Addendum Number 07 (July 18, 2024)

EDINBURG CTE CENTER

Prepared By: PBK Architects, Inc.

PBK Project No.: 20217

ASD101

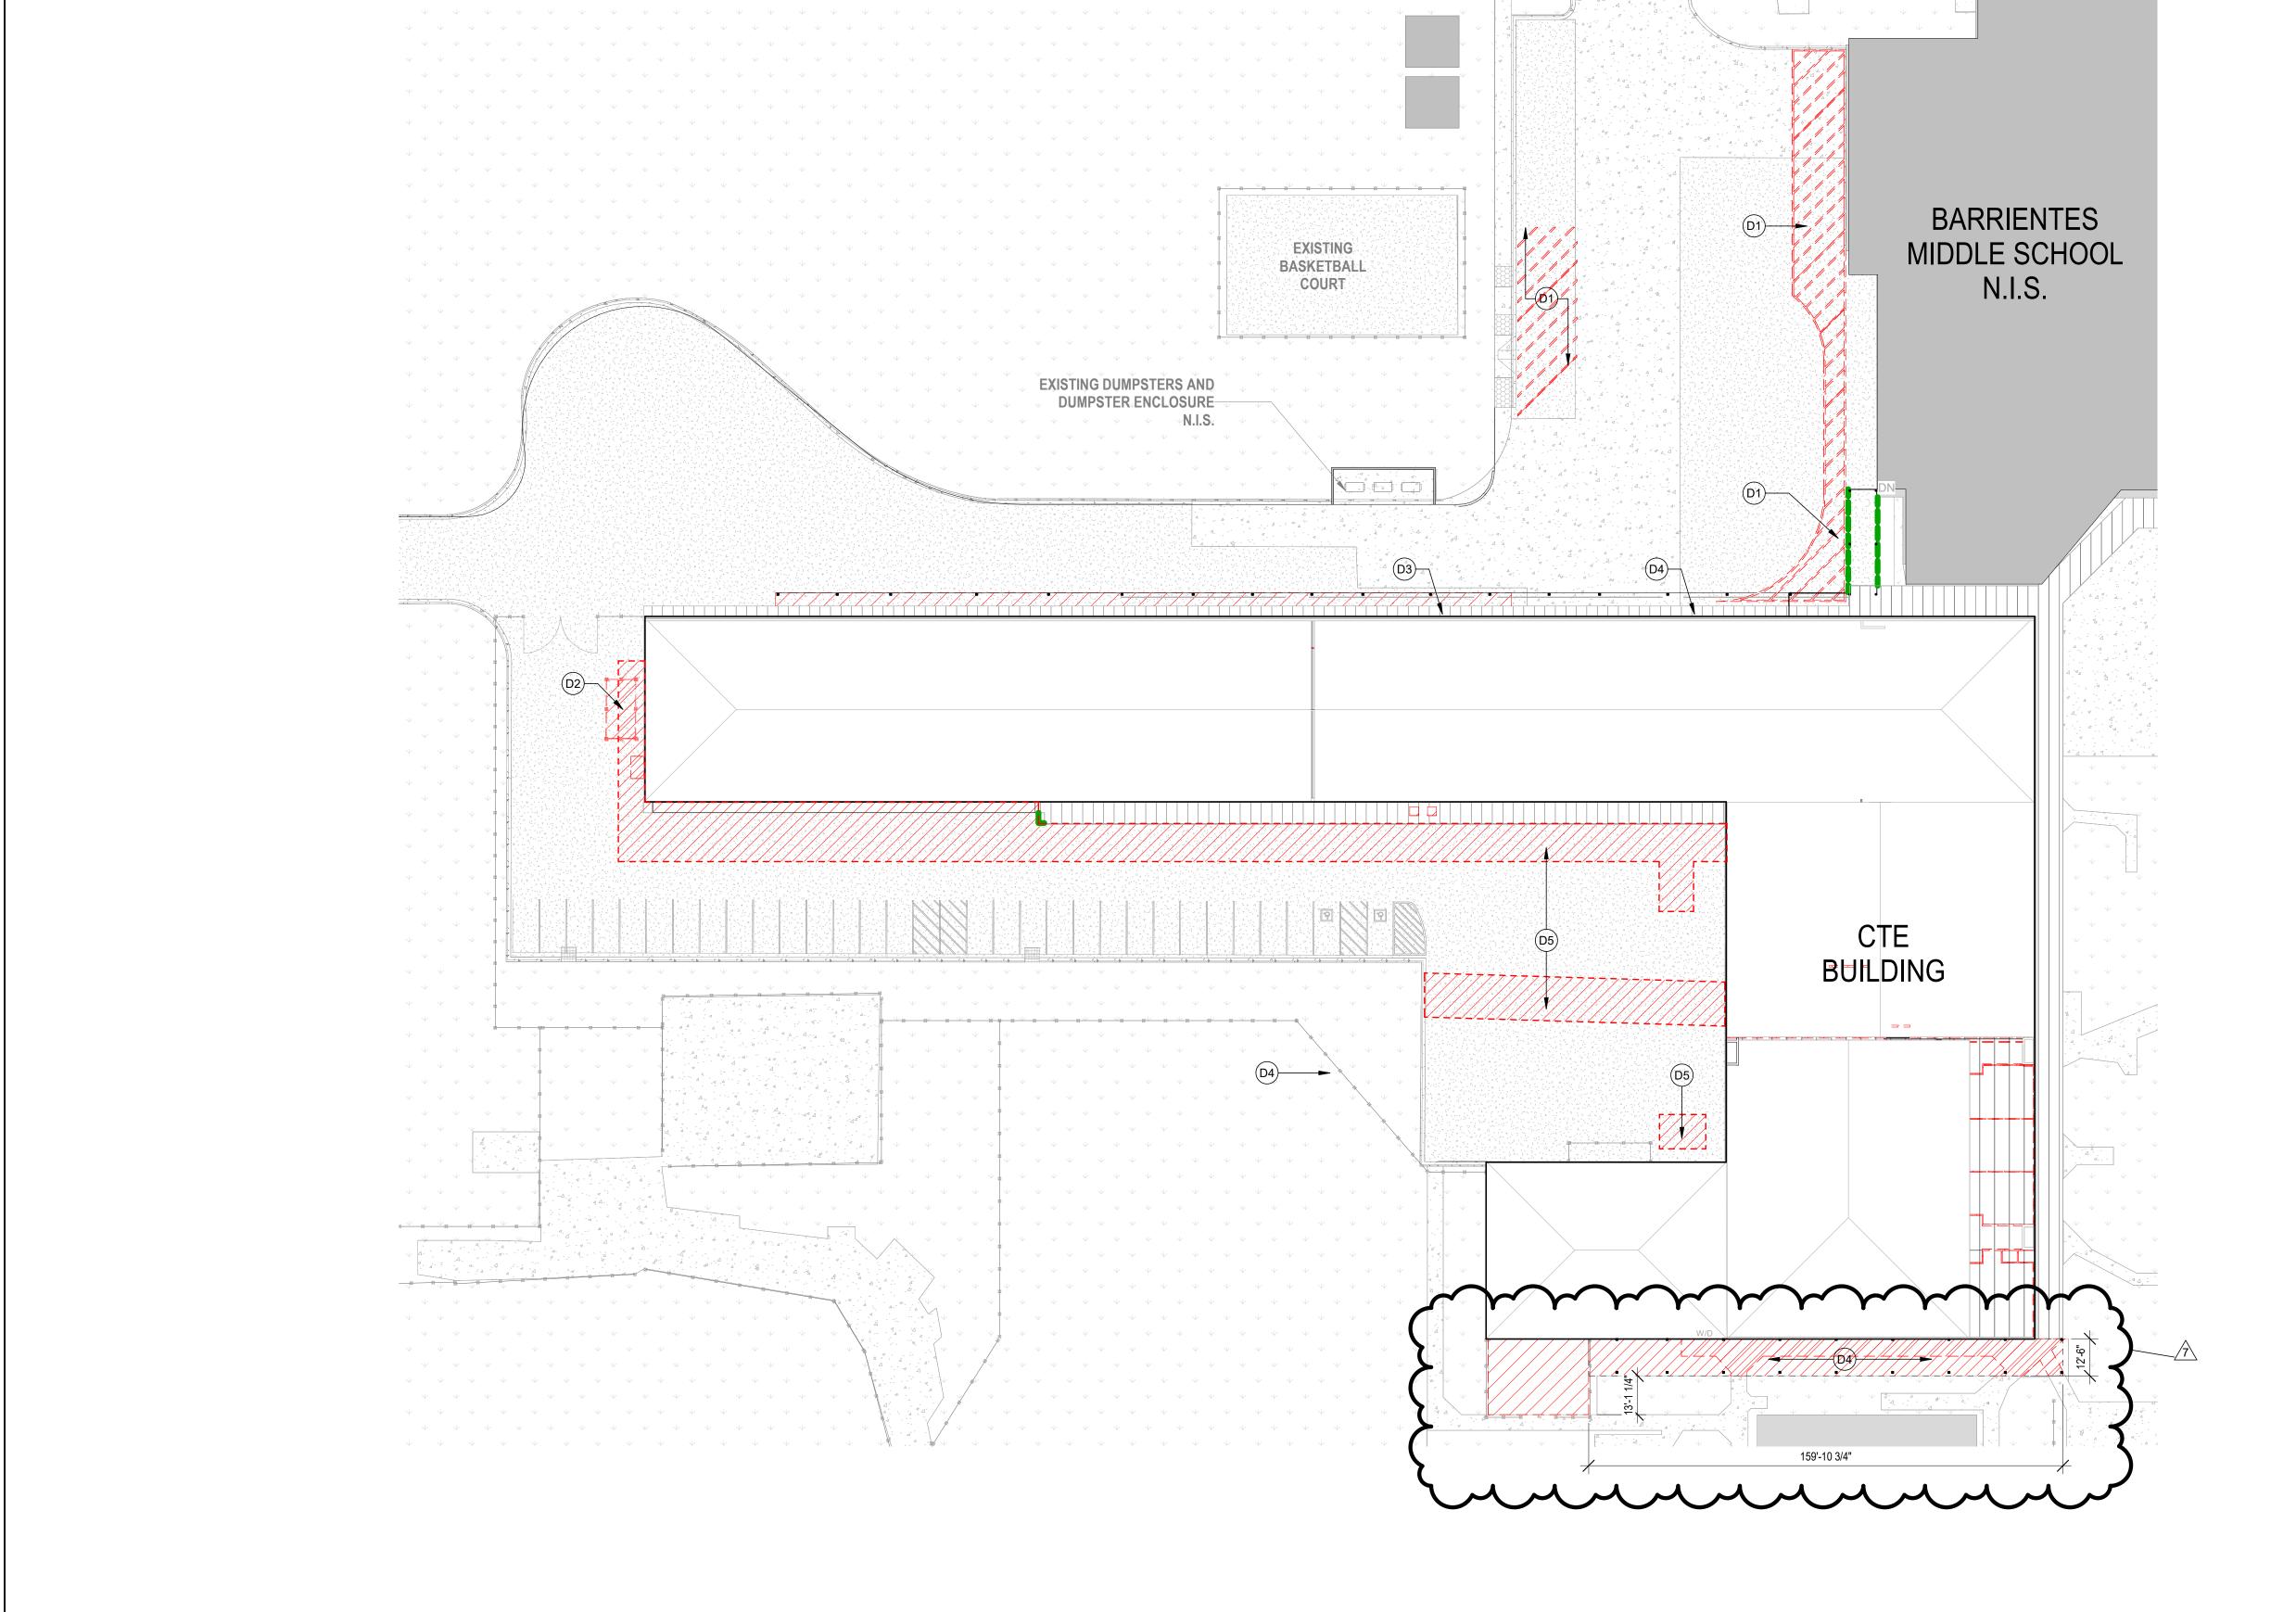
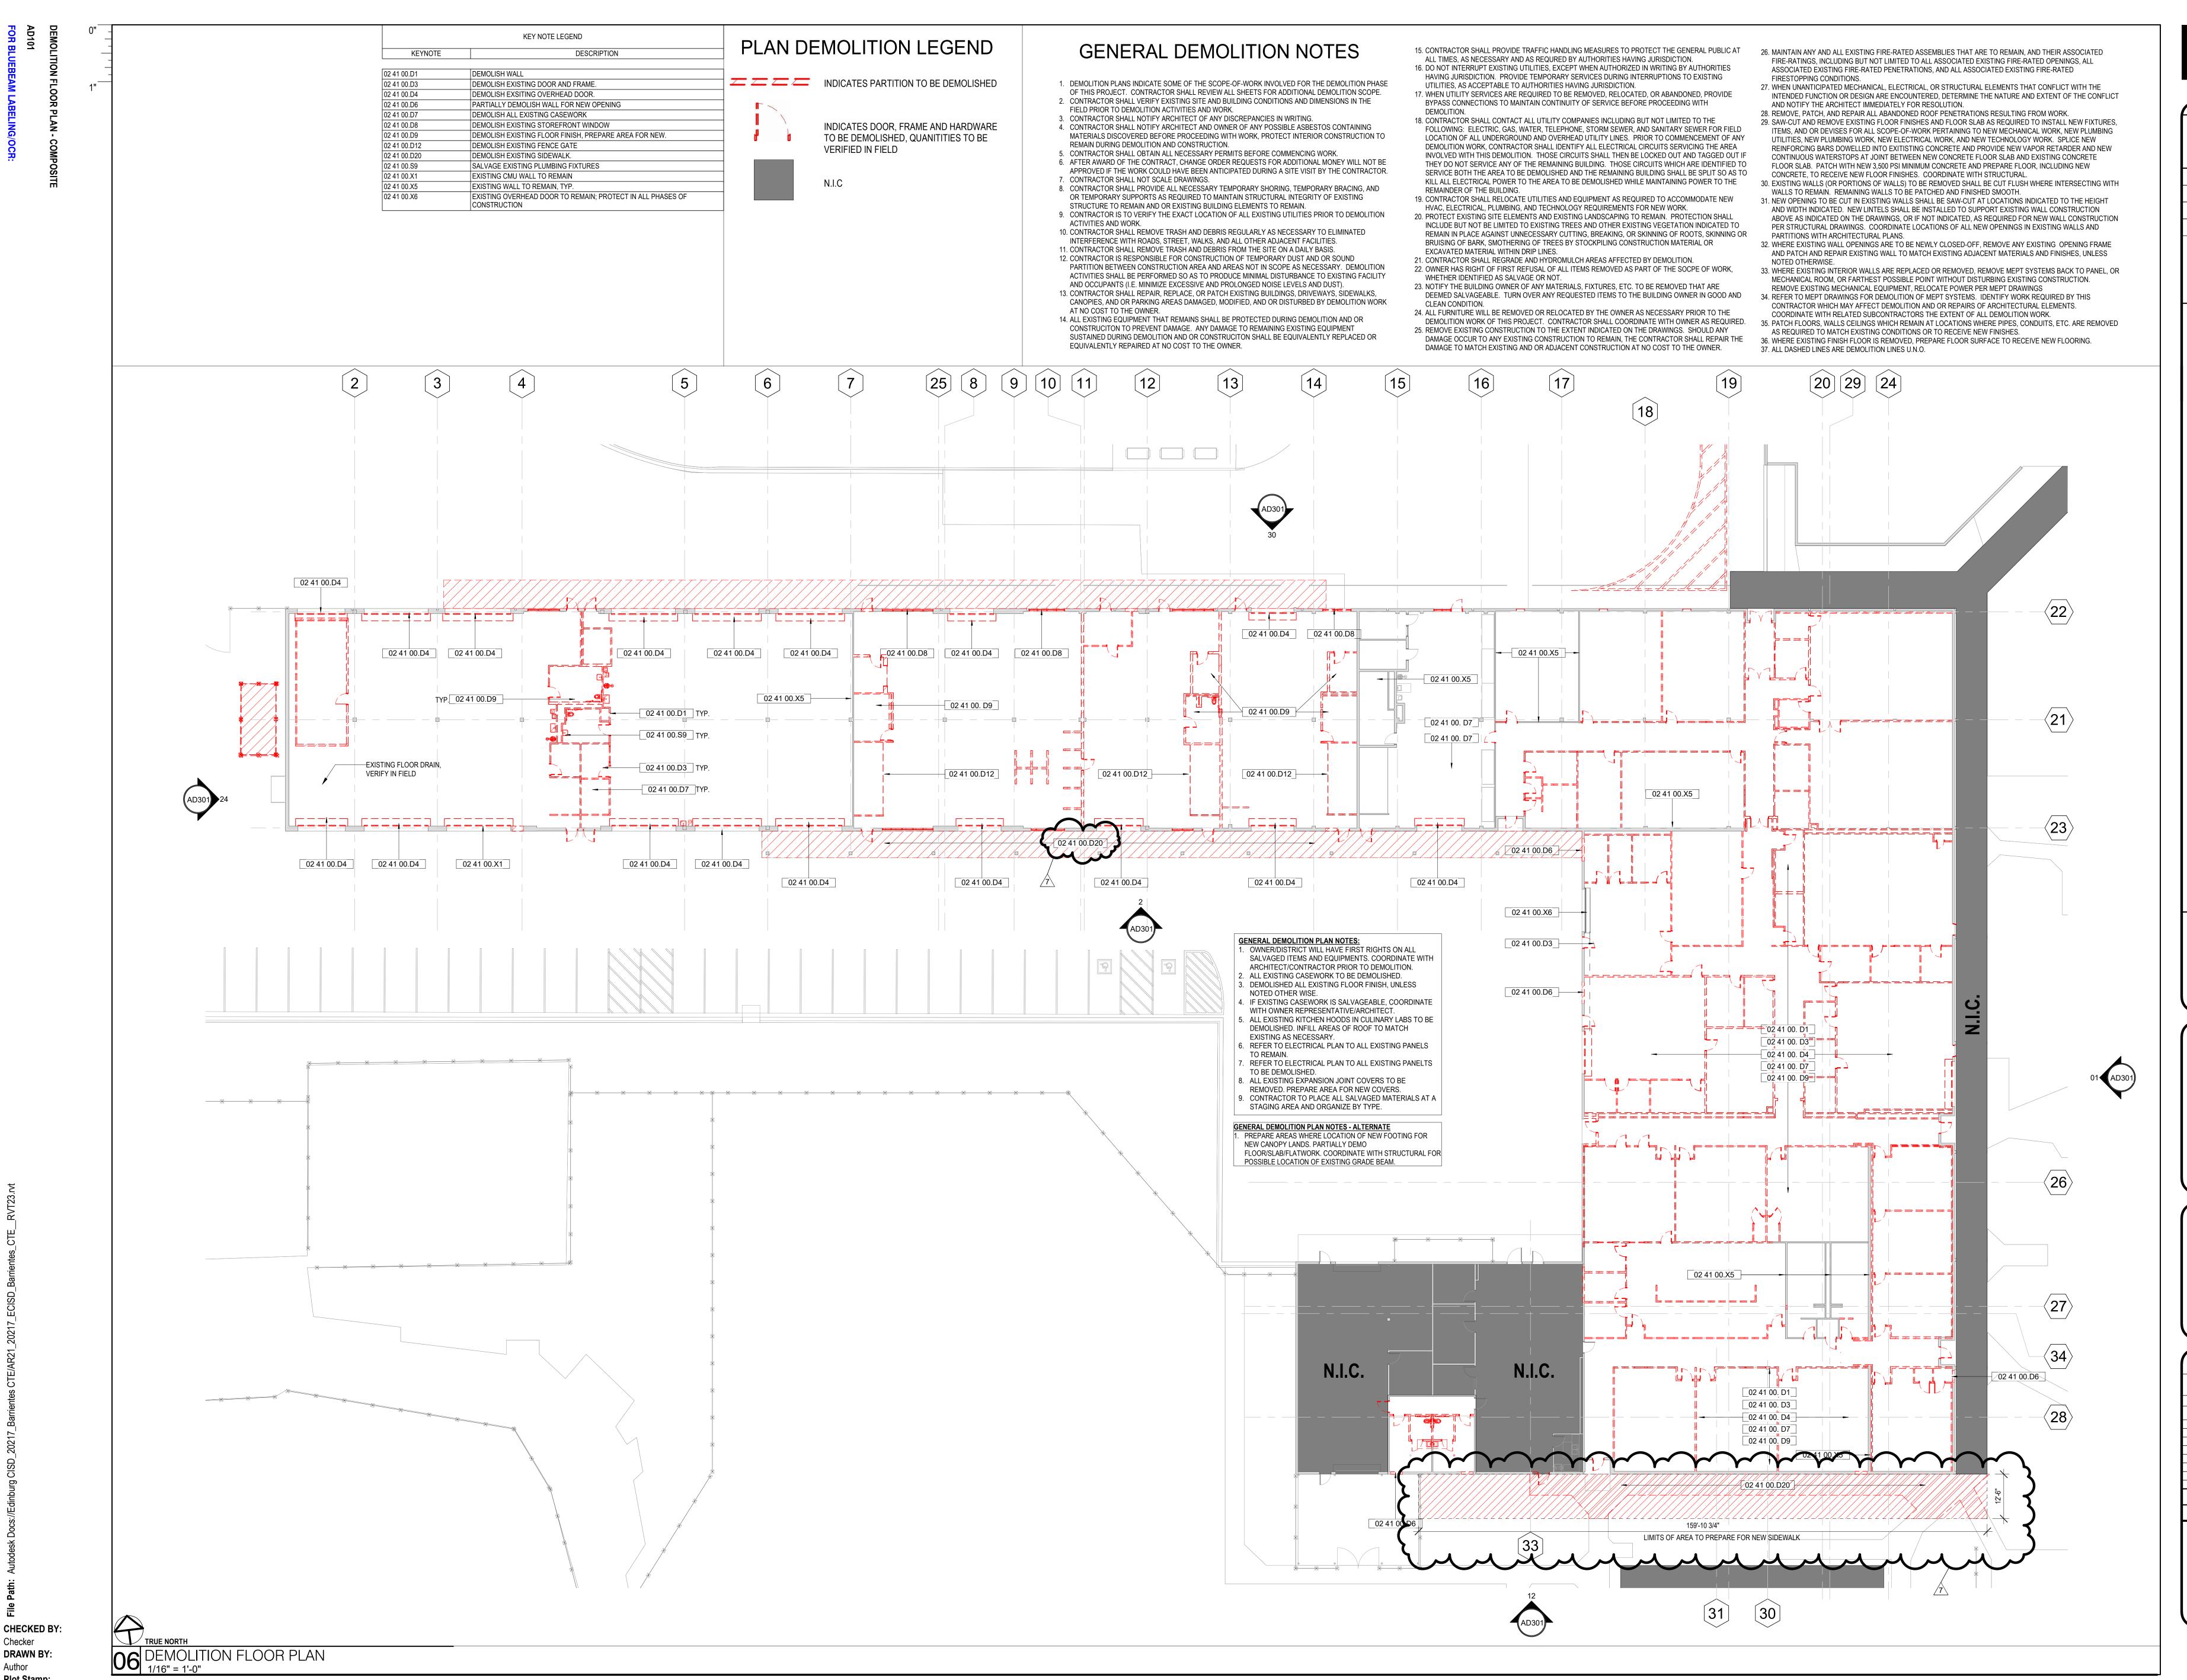
007	Are the sidewalks scheduled at the walkway canopies part of the alternate. If alternate is not accepted is sidewalks required	Sidewalks will be part of base bid	
800	South side of Area C- Alternate 1 Canopy- existing sidewalk does not show being removed	Sidewalk is part of base bid. See attached Sheet revised limits and estimated dimension.

- D2) RELOCATE EXISTING ELECTRICAL EQUIPMENT AND REMOVE CHINLINK FENCE.
- D3) DEMOLISH EXISTING CANOPY. PREPARE FOR NEW CONSTRUCTION.
- D4) PREPARE AREA FOR NEW CANOPY CONSTRUCTION
- (D5) DEMOLISH EXISTING ASPHALT, RE: CIVIL DRAWINGS FOR LIMITS.

A-404

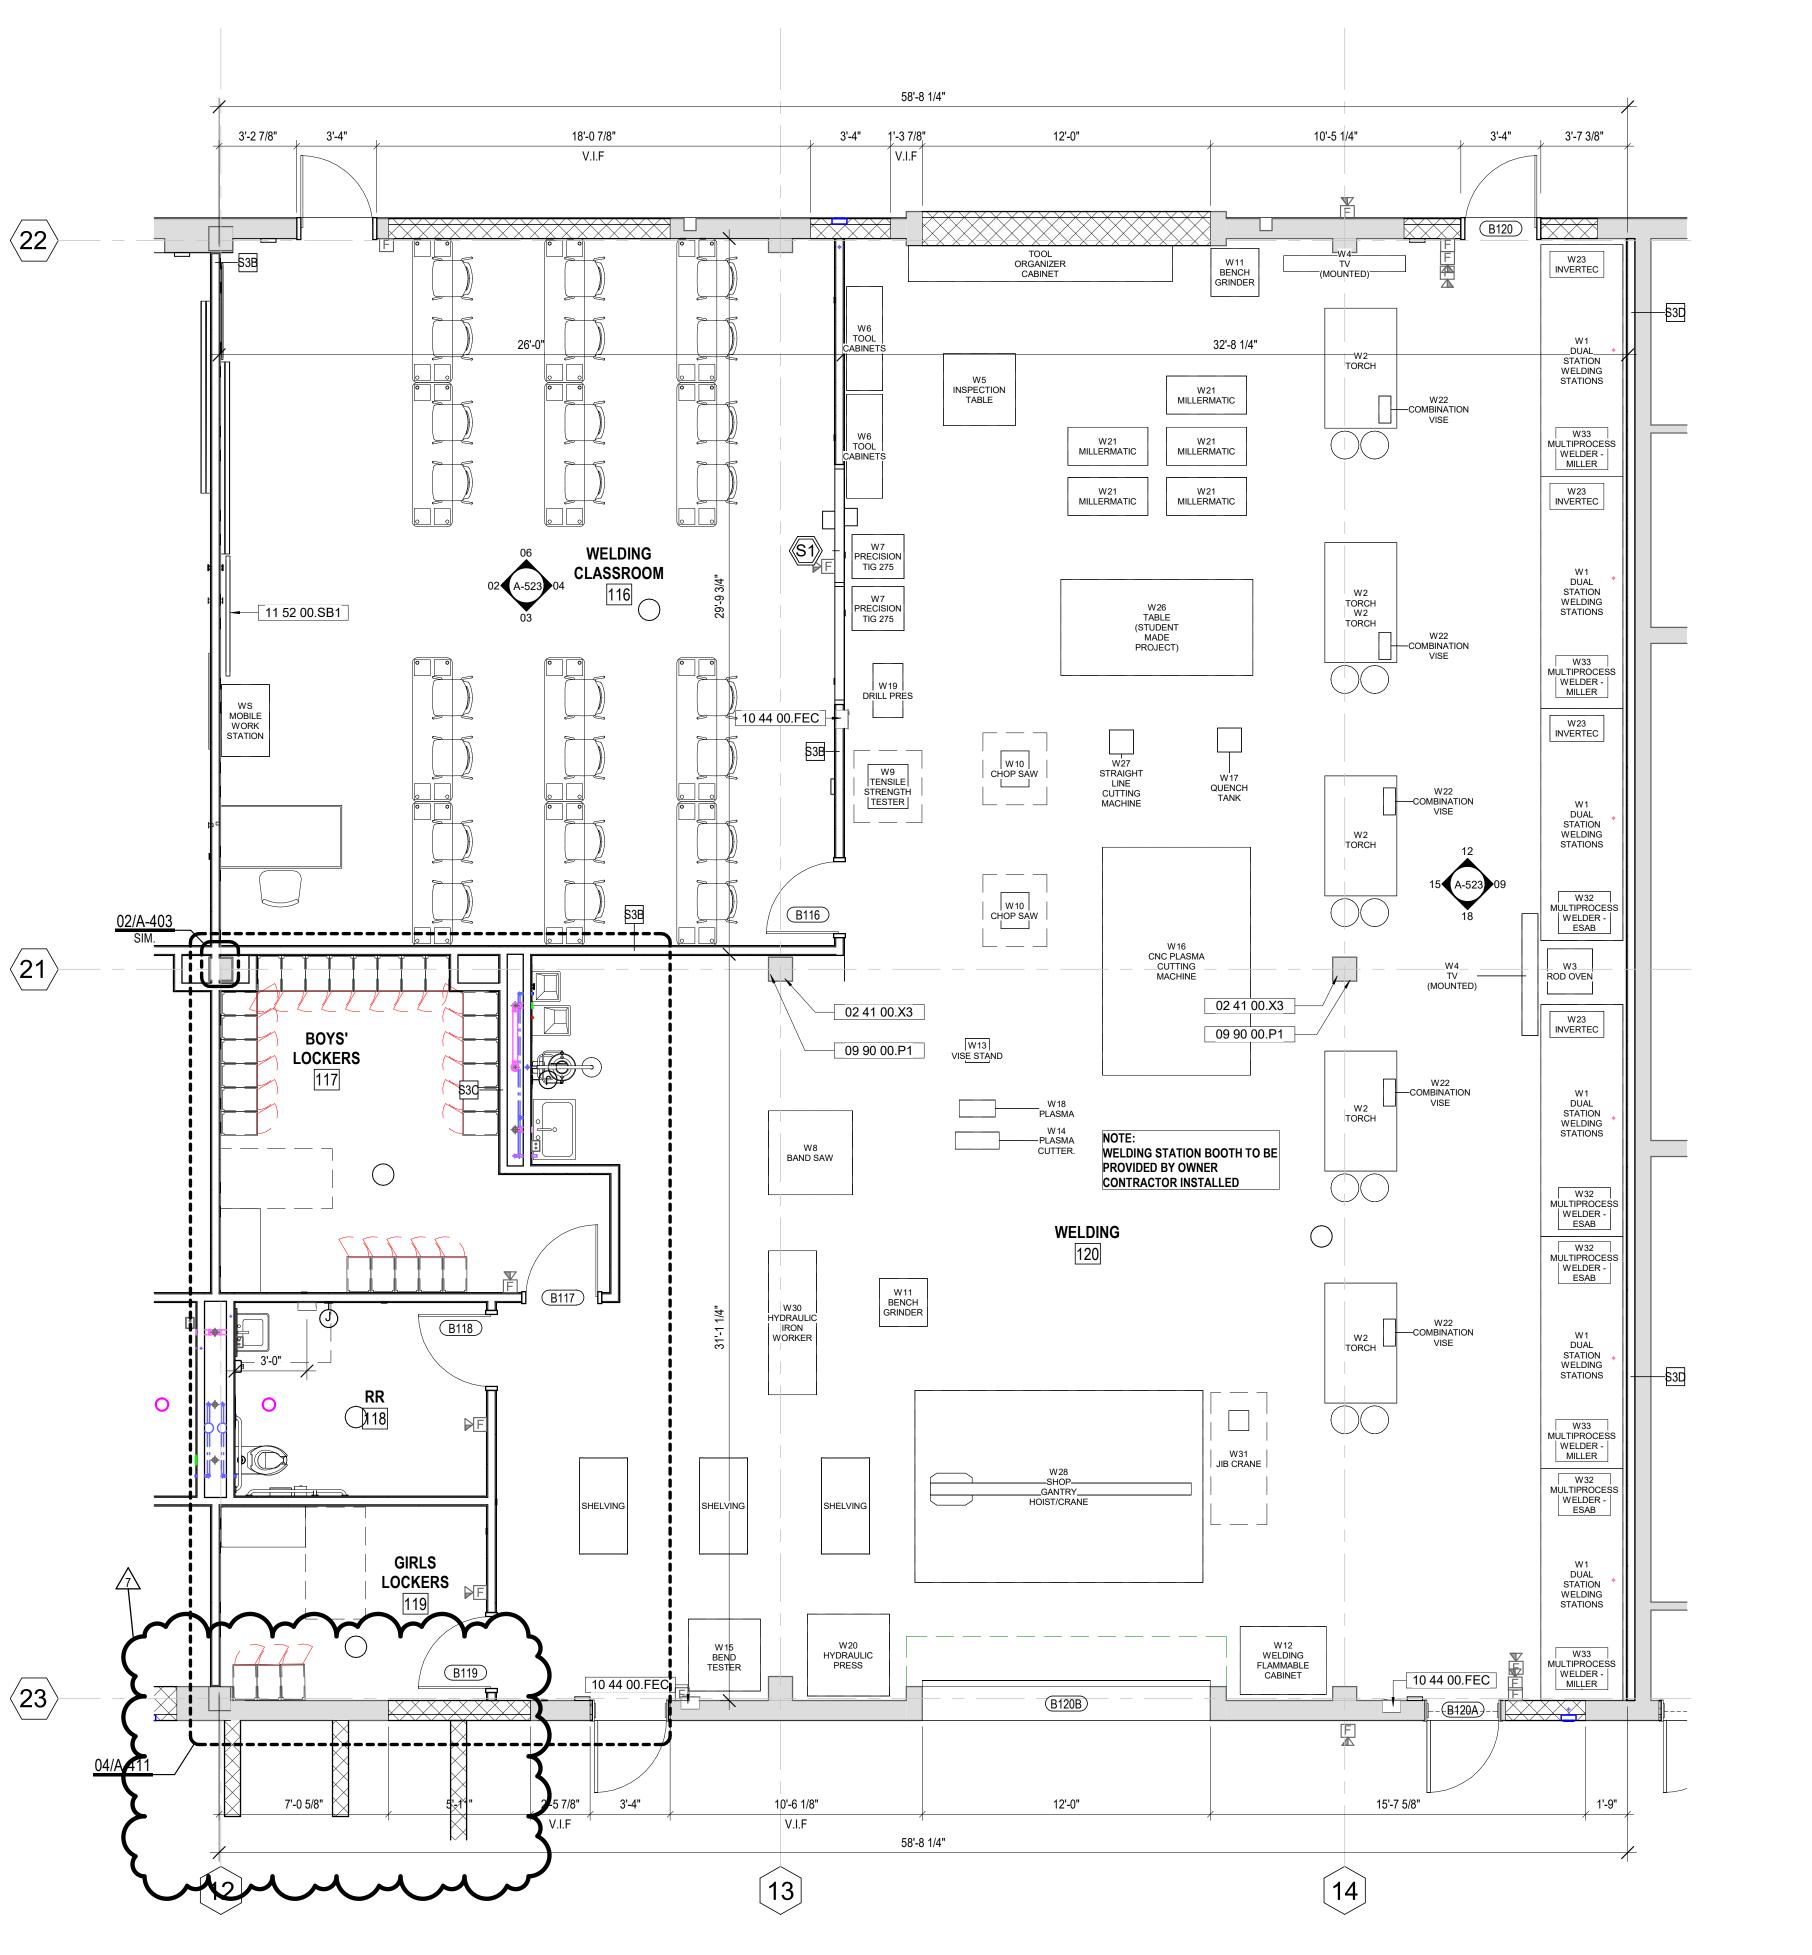
No.	Question	Response	Response By
001	Provide a specification for the car lifts (3 total)	See attached specifications	
002	Where is the location for the Jib and Bridge Lifts	See attached marked sheet for the proposed location. (finalize with owner)	
003	Sheet P-701- Fire Sprinkler Notes 1 and 2- water service and FDC- states to reference Civil for continuation- Civil does not address the continuation	Addressed with ADD#7. Updated C2 and added C2A for alternate and base bid items	
004	Also, if we are to tie into the main on the north side of the plan you are looking at over 1,000 feet run. This might be an issue for water pressure	updated C2 and added C2A for alternate and base bid items	
005	Alternate No. 1 canopy-calls for a canopy on the south side of A-B building. The structural does not show structural footings	See attached Structural drawings	
006	Need additional detail and scope for the removal of existing canopy or overhang at this same location	Removal of existing canopies will only be alternates as accepted. Base bid is to patch and repair. Replace existing canopy soffit is included in the Base bid.
